## Model 240/245R/RX/250R/RX/250PS

New ignition system A new common ignition system has been designed. It has the following advantages:

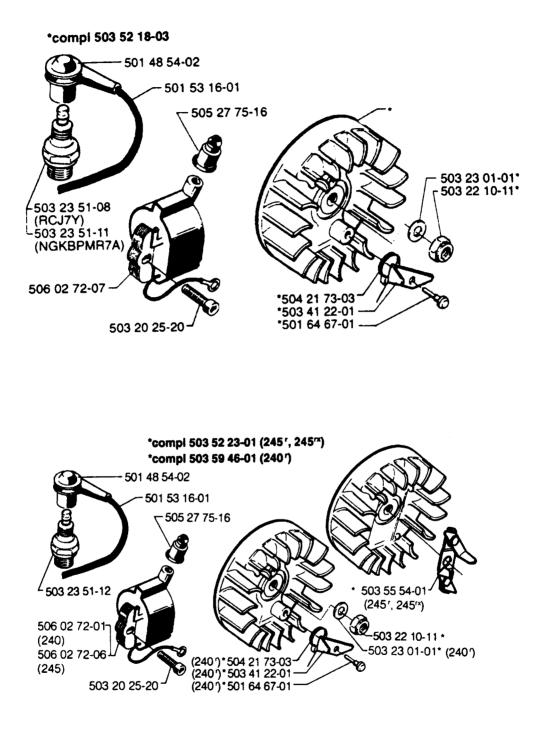
1. New material in the magnets (Neodyne). Higher level of magnetisation, which means that smaller reagents can be used without jeopardizing the effect of the ignition system. A lighter flywheel can also be used.

2. Demagnetisation not possible.

3. Anti-reverse. No sparking when the crankshaft is rotated in the wrong direction.

- 4. Higher sparking intensity. This keeps the sparking plug electrodes cleaner.
- 5. Fewer parts in the bearing.

New ignition modules have a brown earth lead.

- a) New ignition modules can be used with old flywheels.
- b) New flywheels cannot be used with old ignition modules.
